Title: Ceiling Site Investigations_File Note Summary

The purpose of this file note is to summarise the ceiling investigations for The Reveller as discussed on site between the following:

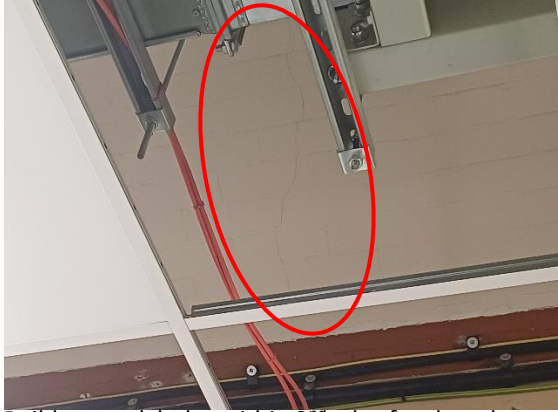
- PD noted mice droppings upon tile removal
- MWP queried waterproofing installation and warranty on 2nd arch rear room (East) – see image below. HRP likely do not have this information, but latest installation would have been 2012.

- HRP to arrange deep clean of the Revellers at wharf level, before 1st May
- Purcell to confirm position on replacement of waterproofing in 2nd wharf arch, rear commercial kitchen room and impact on JFA specification of acoustic plaster.
- Purcell to confirm method for monitoring the soffit and coordinate with HH
- KB further discussion and any concern regarding soffit cracks
